Acoustic Report

**St George Hospital Acute Services Building
Redevelopment**

Schematic Design Report

GA Plans - Level 4 Zone 1

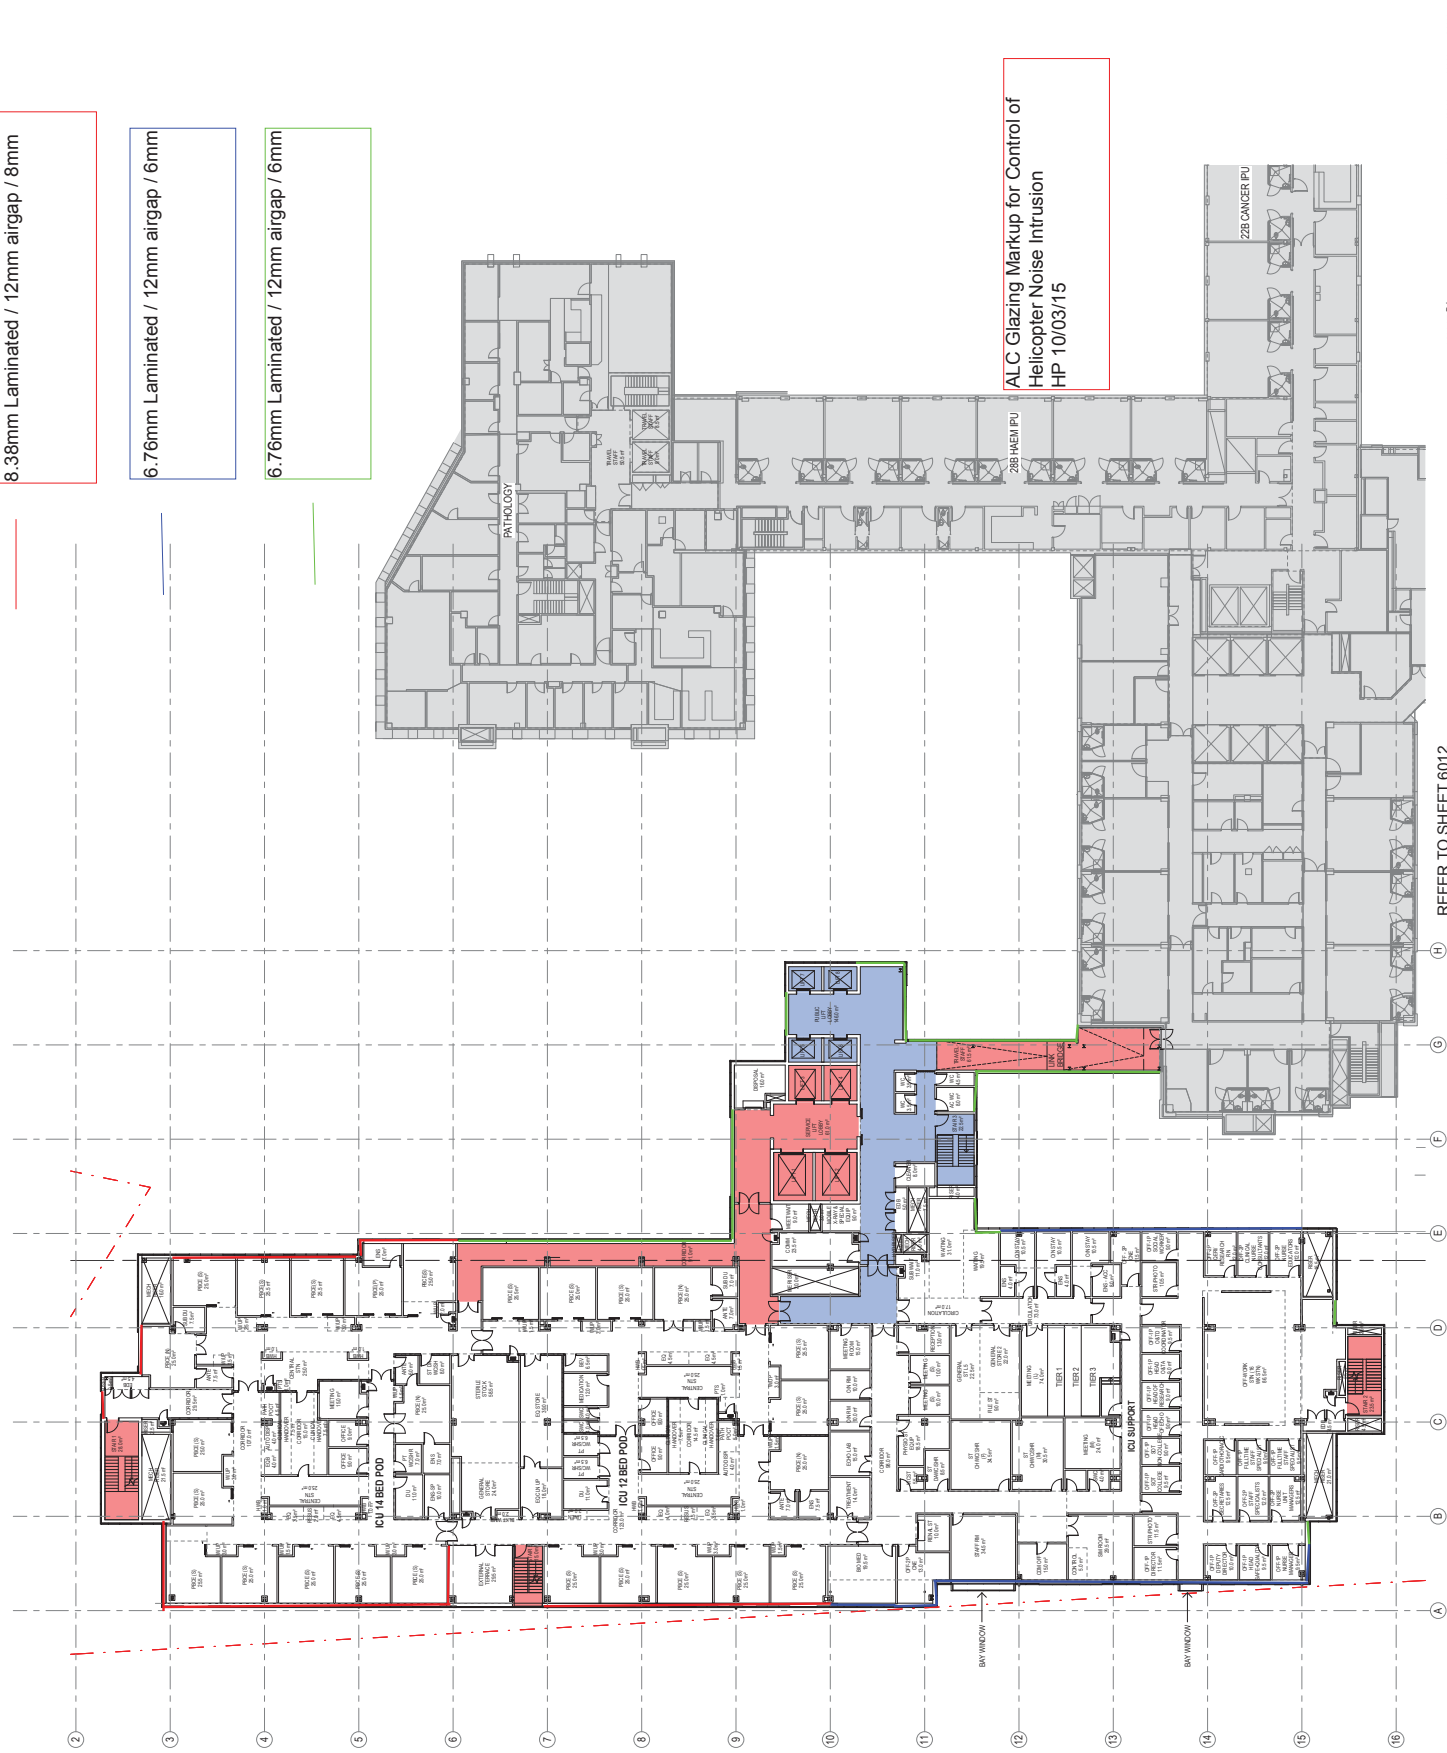
8.38mm Laminated / 12mm airgap / 8mm

GA Plans - Level 7 Zone 1

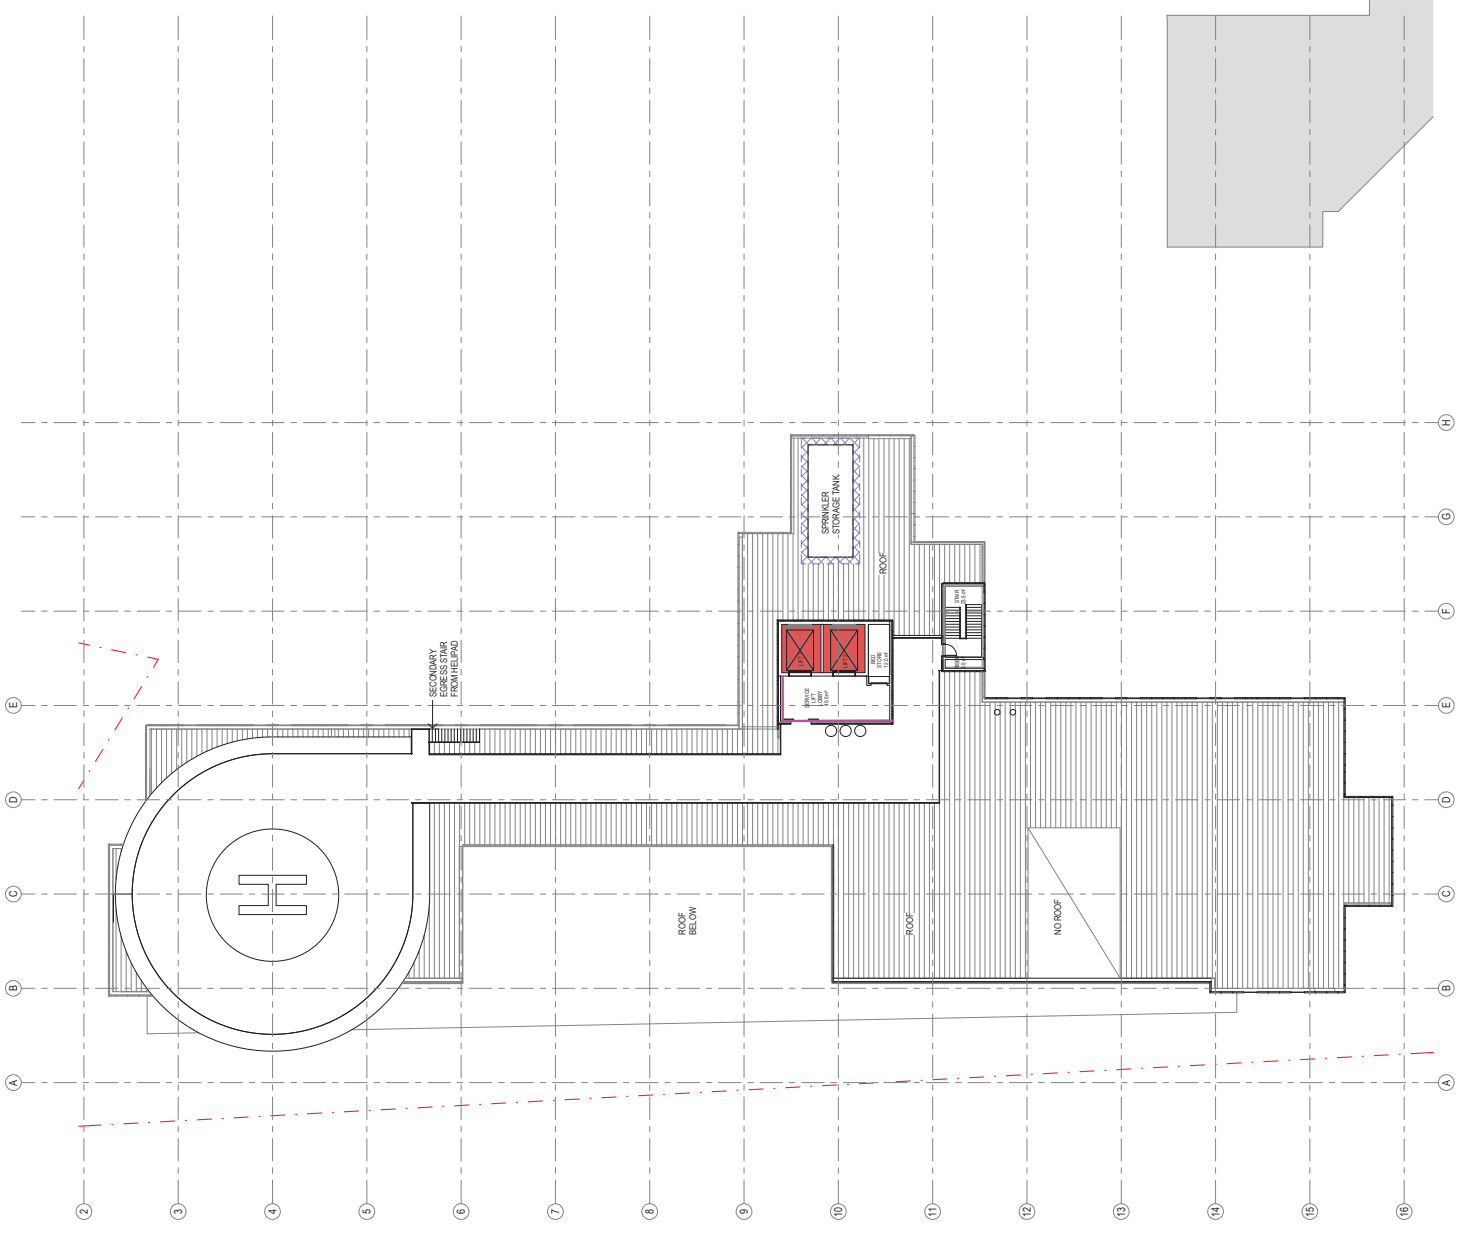
ALC Glazing Markup for Control of Helicopter Noise Intrusion HP 10/03/15

GA Plans - Level 9 Zone 1

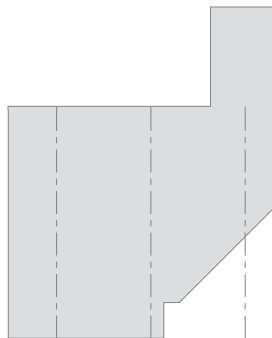
Glazing to architect's detail

ALC Glazing Markup for Control of Helicopter Noise Intrusion HP-10/03/15
